Reference: Hanford Waste Vitrification Plant
DOE Contract DE-AC06-86RL10838
Fluor Contract 8457

DESIGN CHANGE NOTICE

DCN - 0188

DCN TITLE *ADD PAD MOUNTED
GEAR TO PRIMARY 13.8 KV
FEEDER FOR OAB/TOB
BUILDING*

NEW PAD MOUNTED GEAR
INSTALLATION DIAGRAM

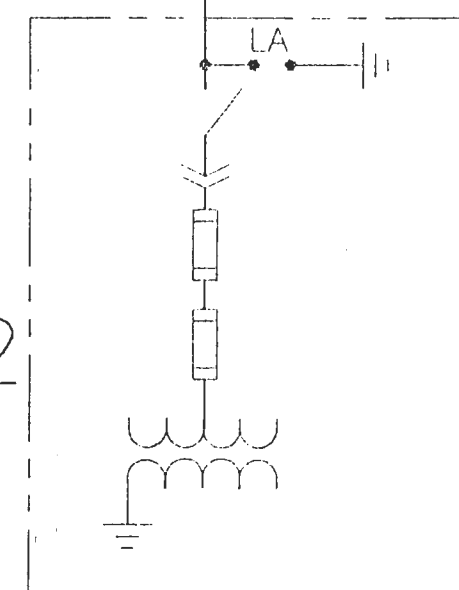
*ADD PAD MOUNTED GEAR NORTH OF MH-P51 FOR PRIMARY 13.8 KV
FEEDER FOR OAB/TOB BUILDING.*

*PAGE 8; ADDED LIGHTNING ARRESTER & NOTE #7
PAGE 10; ADDED LIGHTNING ARRESTER*

1. NEW PAD MOUNTED GEAR SHALL BE S & C MODEL PMH-7CN9, 14.4 kV.
2. PAD MOUNTED GEAR SHALL BE INSTALLED AND TESTED IN ACCORDANCE WITH MANUFACTURER'S INSTRUCTIONS AND SPEC SECTIONS B-595-C-A170-16100 AND 16905.

3. PULL BACK EXISTING CONDUCTORS P8300A,B,C @ MH-P51 FROM TRANSFORMER XT-32A-099. CUT CABLES (LENGTH AS REQUIRED) & INSTALL TO NEW PAD MOUNTED GEAR DD-32A-100 IN NEW CONDUIT (P-8322) FOR TERMINATION HARDWARE SEE MATERIAL SPECIFICATION B-595-C-A170-16110.

4. INSTALL NEW CONDUCTORS P8304A,B,C FROM NEW PAD MOUNTED GEAR DD-32A-100 TO TRANSFORMER XT-32A-099 VIA MANHOLE MH-P51
5. CONDUIT & CABLE INSTALLATION SHALL BE PER SPECIFICATION B-595-C-A170-16100.

6. CONDUCTORS P8300A,B,C AND P8304A,B,C SHALL BE TESTED AFTER INSTALLATION IN ACCORDANCE WITH SPECIFICATION SECTION B-595-C-A170-16905.
7. NEW PAD MOUNTED GEAR SHALL BE SUPPLIED WITH A METAL OXIDE SURGE ARRESTER S & C TYPE N9. INSTALL ARRESTER PER MANUFACTURERS INSTRUCTIONS.

OAB/TOB SERVICE ONE LINE DIAGRAM

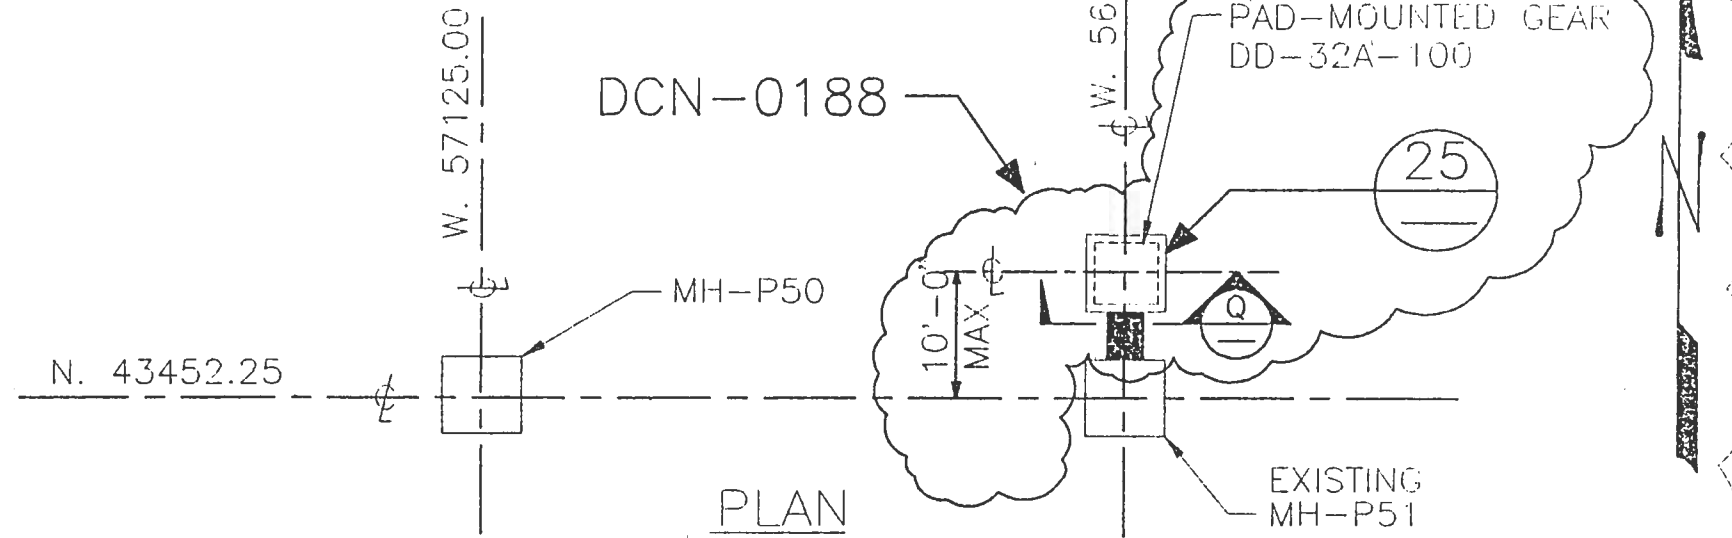
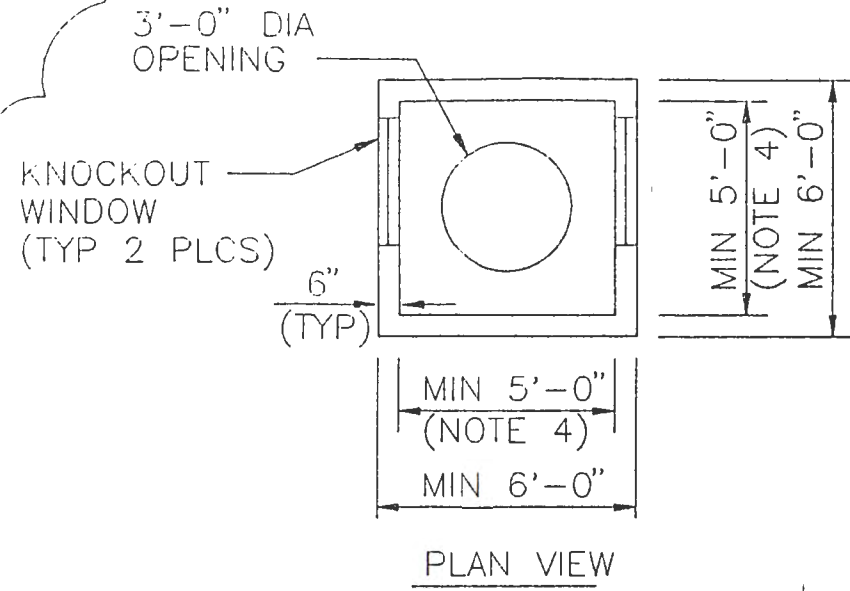
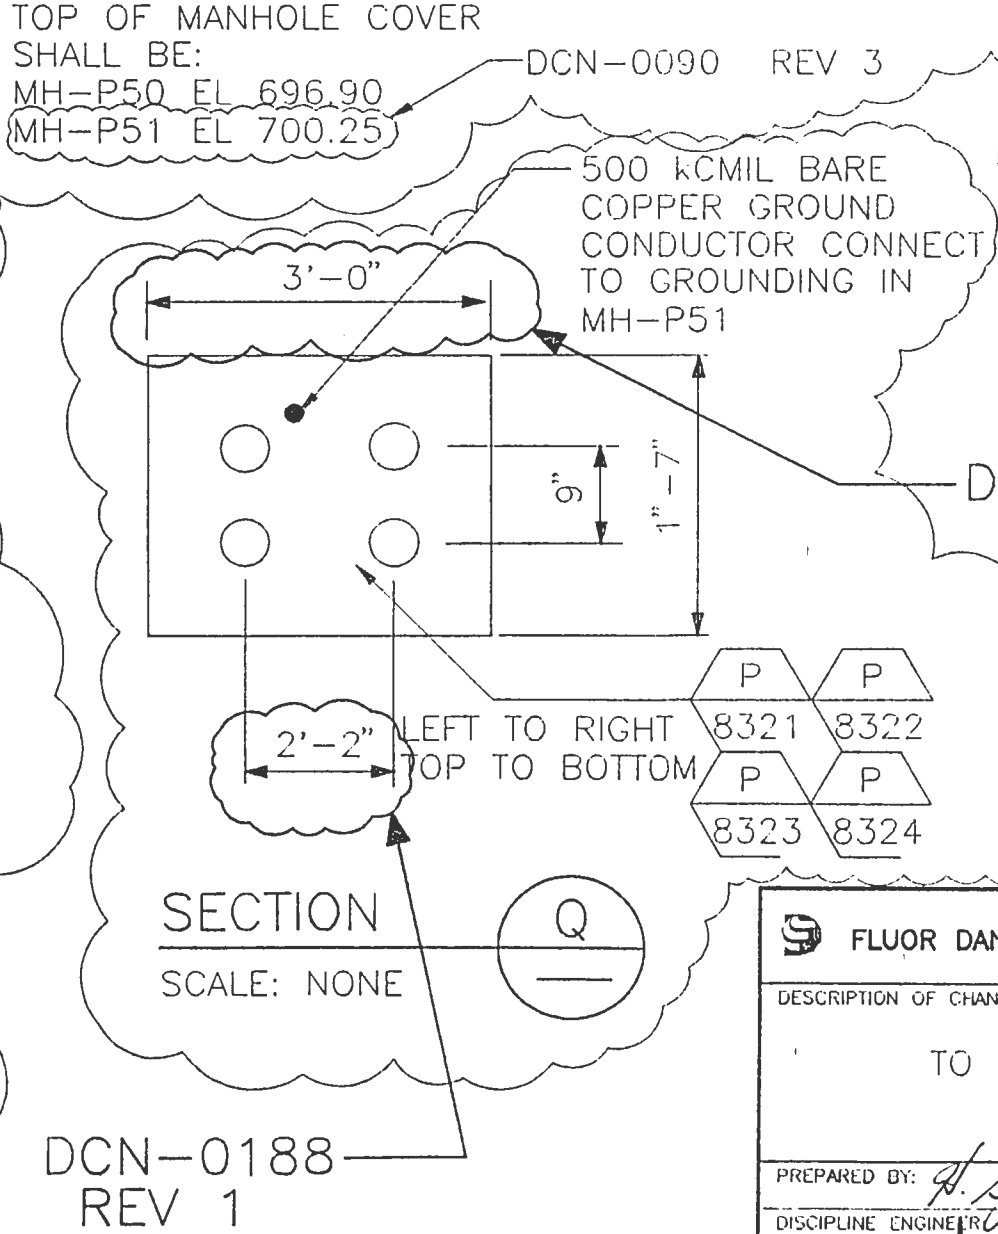
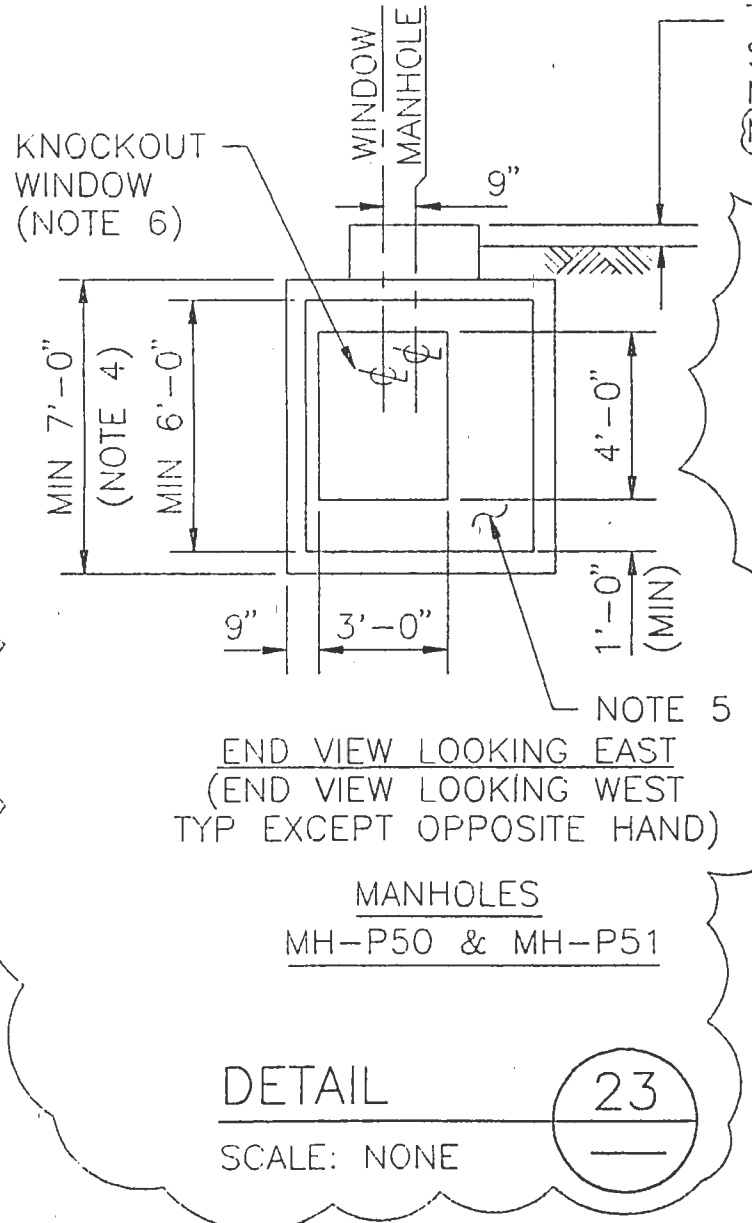
*PAGE 8; REVISED CONDUIT CALLOUTS
PAGE 10; ADDED CLOUD TO NOTE #5
PAGE 11; REVISED ELECTRICAL DIRT
PAGE 12; REVISED CONDUIT STRIP-UP SPACING
PAGE 13; REVISED CONCRETE PAD & ANCHORING OF PAD MOUNTED GEAR*

DD-32A-100
NEW PAD-MOUNTED GEAR

P8304
(SEE NOTE 3)

NOTE:
THE INFORMATION CONTAINED ON
THIS PAGE TO BE INCLUDED ON
SHEET 4 OF DRAWING H-2-122134
WHICH WILL BE ADDED AT THE
NEXT REVISION.

SECTION "A-A"

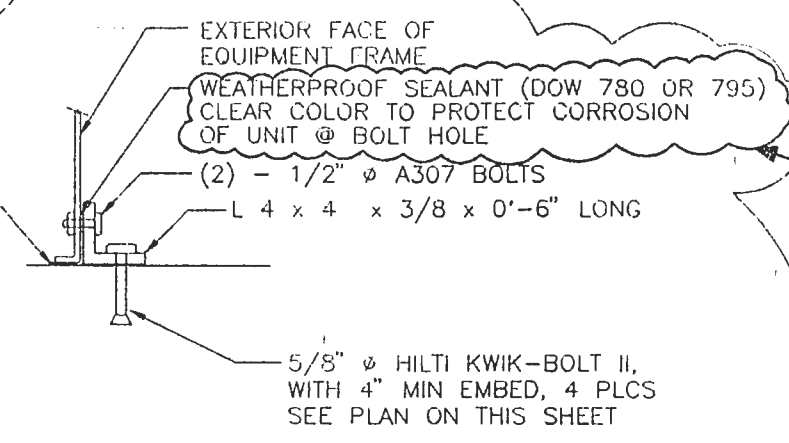
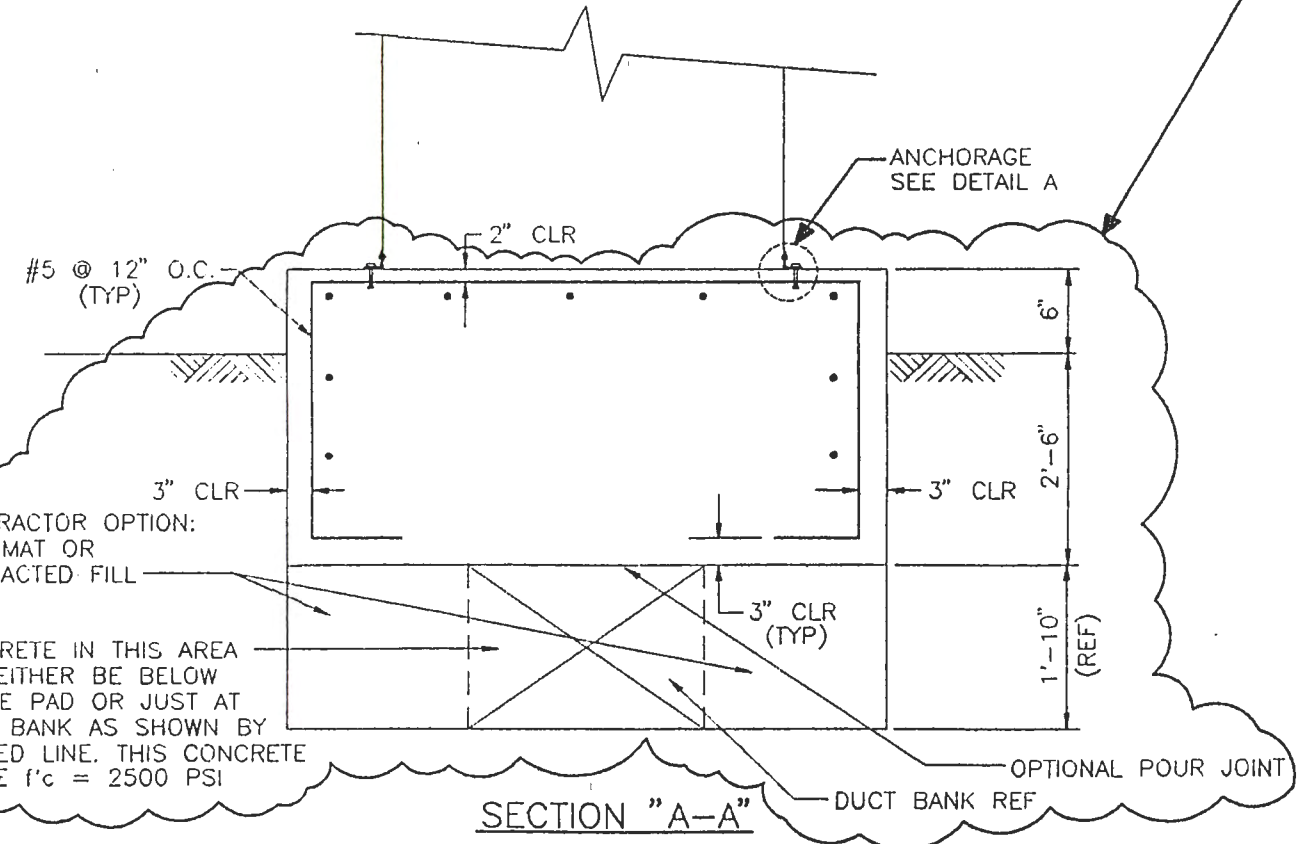
DOCUMENT NUMBER	SHT/PAGE	REV NO	DOCUMENT NAME	INCLD Y/N	DESCRIPTION OF CHANGE
H-2-118063 REV 1 CHANGE	1	2	DISCONNECT SWITCH PAD FOUNDATION	Y	ADDED PAD FOUNDATION FOR PAD MOUNTED GEAR NORTH OF MH-PS1

1. KWIK-BOLT II SHALL NOT BE INSTALLED UNTIL CONCRETE HAS REACHED $f'c = 2500$ PSI.
2. REINFORCING MAY BE MOVED UP TO 3" FOR CONDUIT BUT AVERAGE SPACING TO STAY AS SHOWN. ALT.: IF A BAR HAS TO BE REMOVED FOR A CONDUIT, ADD EQUIVALENT REINE. ADJACENT TO UNREINFORCED ZONE.
3. SEE SHEET H-2-118060 SHEET 1 FOR STRUCTURAL GENERAL NOTES & TYPICAL DETAILS.
